H11073

## DESCRIPTIVE REPORT

*Registry No.* H-11073

# Descriptive Report to Accompany Hydrographic Survey H11073

Figure 2. H11073 Junction Surveys.

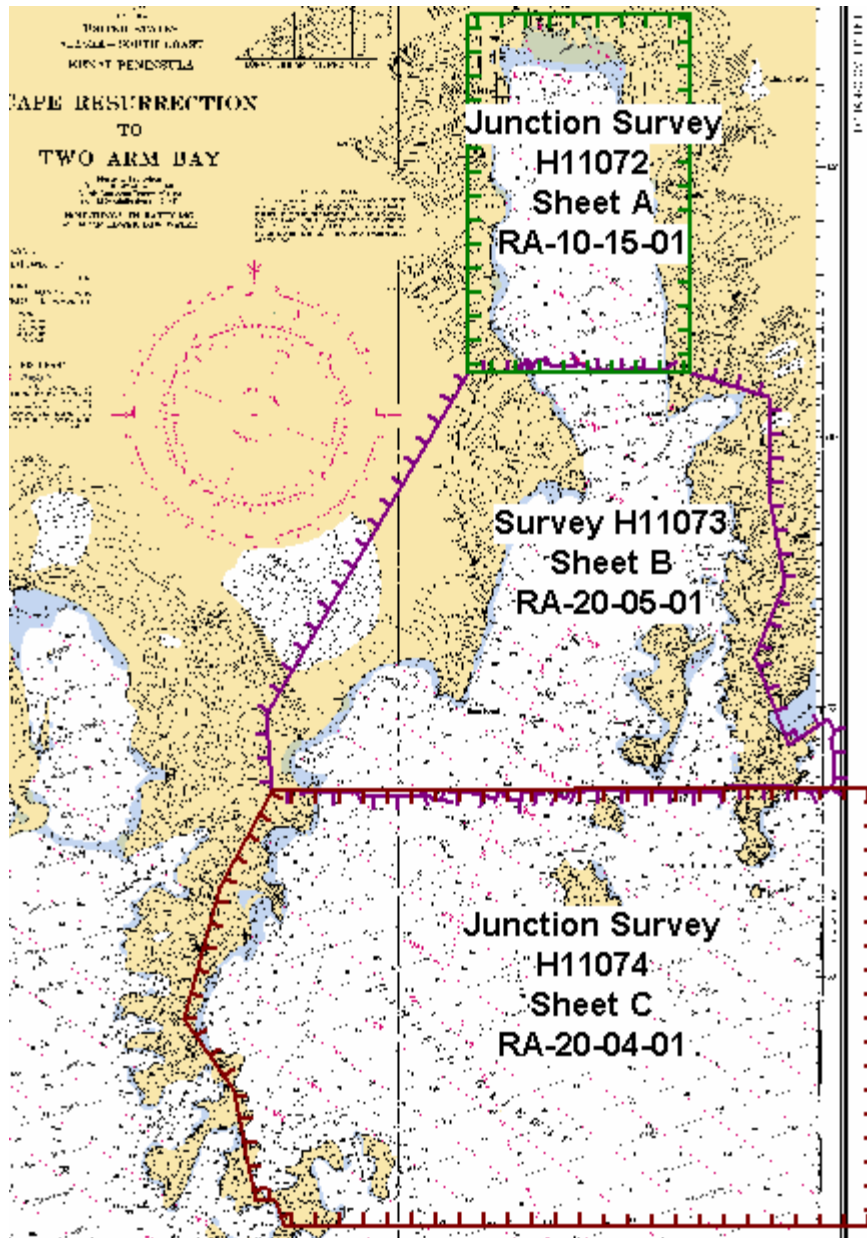
The following contemporary surveys junction with H11073 (see Figure 2):<sup>9</sup>

Survey H11072 junctions well with this survey, with differences generally less than one fathom.<sup>10</sup>

Survey H11074 was not completed prior to submittal of survey H11073. Junction comparisons will be performed upon completion.<sup>11</sup>

- <sup>5</sup> Filed with the project records
- <sup>6</sup> Concur.
- <sup>7</sup> Filed with the hydrographic records.
- <sup>8</sup> Concur.
- <sup>9</sup> The junctions with H11072 and H11074 are complete. A “Joins” note has been added to the smooth sheet where applicable.

- <sup>10</sup> Concur. Refer to endnote 9.
- <sup>11</sup> Concur. Refer to endnote 9.
- <sup>12</sup> Concur.
- <sup>13</sup> Concur.
- <sup>14</sup> Filed with the project records.

Figure 3. New wreck in Thumb Cove

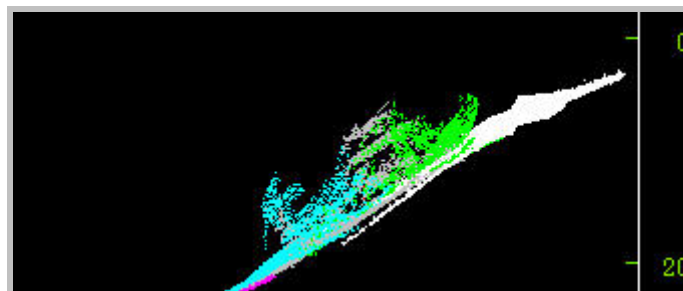
A new wreck was found in Thumb Cove (Figure 3) at (Pos 53345, 60-00-39.89 N, 149-17-25.61 W; 372,303.9 E, 6,654,856.3 N). The least depth of the wreck was 4.6m. The Hydrographer recommends charting the new wreck as depicted on the DPBS Plot. <sup>29</sup>

- <sup>28</sup> Concur with clarification. The disproved islet is not shown on the current edition of the chart. Chart as depicted on the Hdrawing
- <sup>29</sup> Concur. Chart as depicted on the Hdrawing.

Figure 4. CFF Shoreline Discrepancies

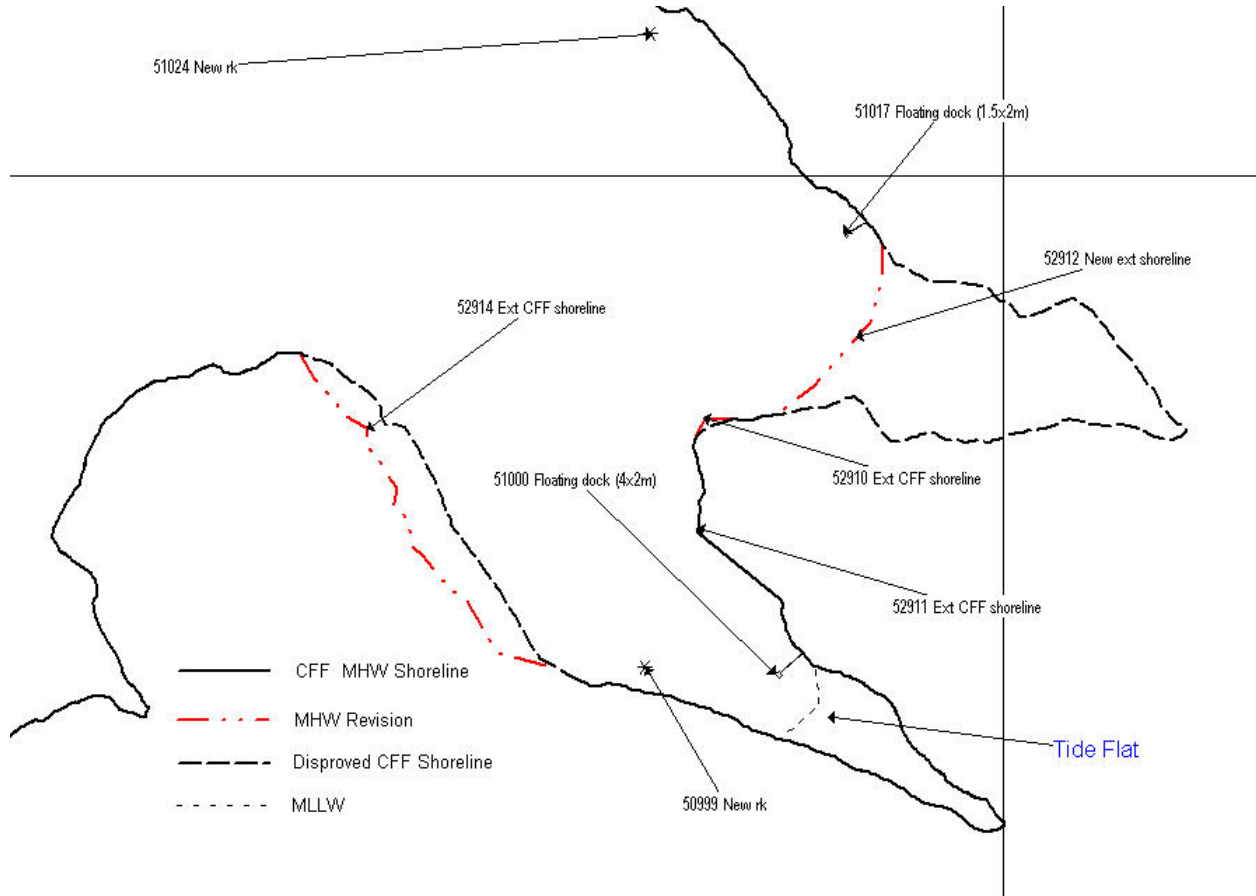
There was a discrepancy between the CFF and existing shoreline (see Figure 4) at 59-57-52.60N, 149-16-49.32W (372,686.0E, 6,649,663.8N). A new approximate HW line was drawn based on (Pos 52910 and 52912, 59-54-43.07N, 149-17-43.68W; 372,397.8E, 6,649,757.9N) and SWMB coverage. The Hydrographer recommends revising the CFF shoreline to the new approximate HW line depicted in the DPBS Plot. <sup>30</sup>

There was a discrepancy between the CFF and existing shoreline (Figure 4) at 59-57-50.61 N, 149-17-31.68 W (372028.5 E, 6649624.9 N). A new approximate HW line was drawn based on (Pos 52914, 59-57-52.68N, 149-17-36.03W; 371,963.3E, 6,649,691.3N) and SWMB coverage. The Hydrographer recommends revising the CFF shoreline to the new approximate HW line depicted in the DPBS Plot.<sup>31</sup>

- <sup>30</sup> Concur.

- 
- <sup>31</sup> Concur.
- <sup>32</sup> Concur.
- <sup>33</sup> Concur.
- <sup>34</sup> Concur.
- <sup>35</sup> Concur.
- <sup>36</sup> Concur. Chart as depicted on the Hdrawing.
